ZONING CHANGE REVIEW SHEET

CASE: C14-2015-0015 – Sunset Trail Residences **P.C. DATE:** April 28, 2015
May 12, 2015

ADDRESS: 4704, 4706, 4800 and 4802 Sunset Trail

ZONING FROM: SF-2-NP **TO:** MF-2-NP **AREA:** 2.75 acres

*EXHIBIT C
 CONCEPTUAL PLAN*

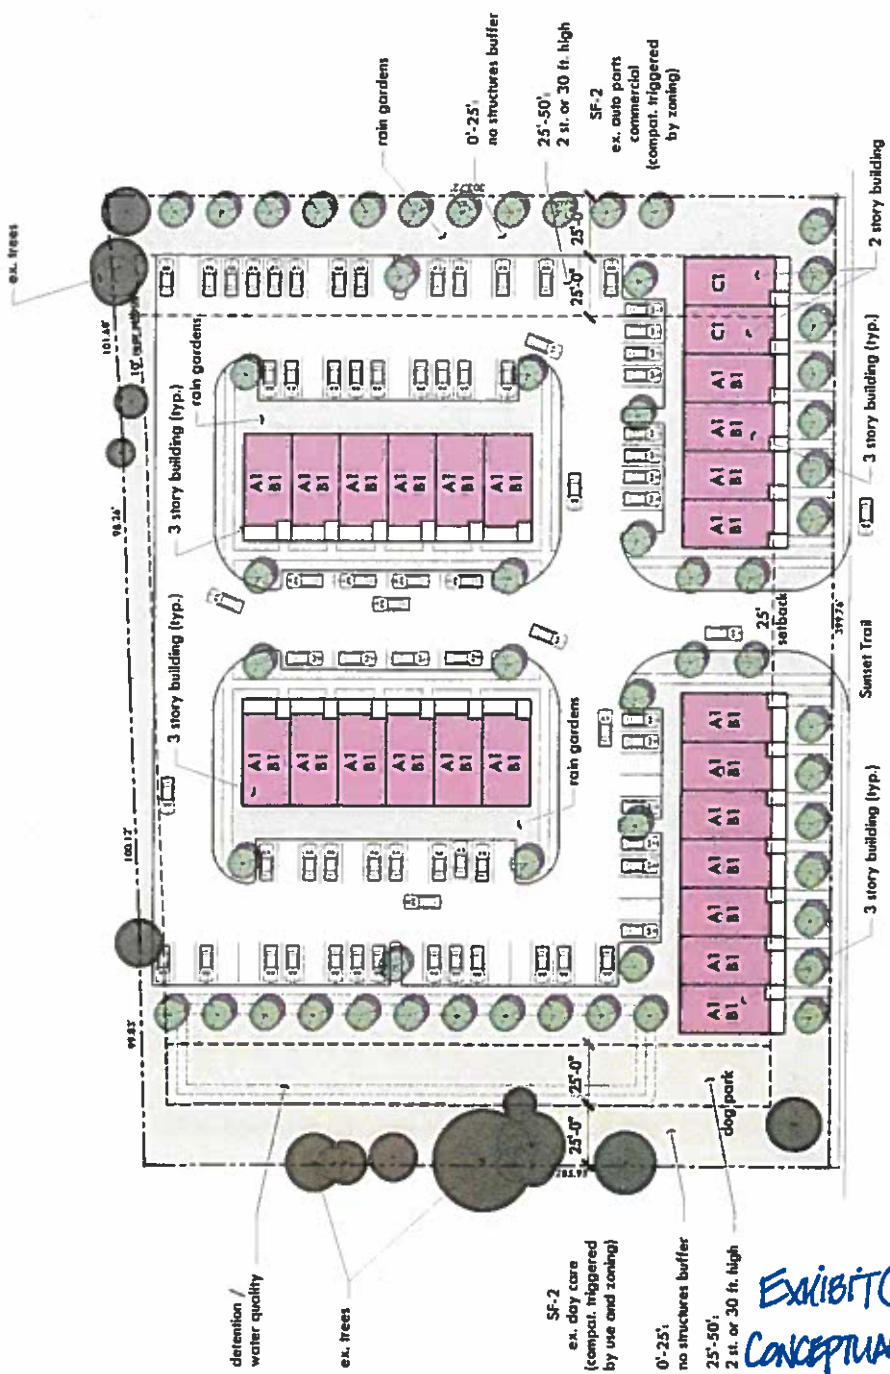
The City of Sunset Valley has concerns that there is no proposed buffering on the west side of the subject property. As the owner of this property, we would expect that some buffering would be provided.
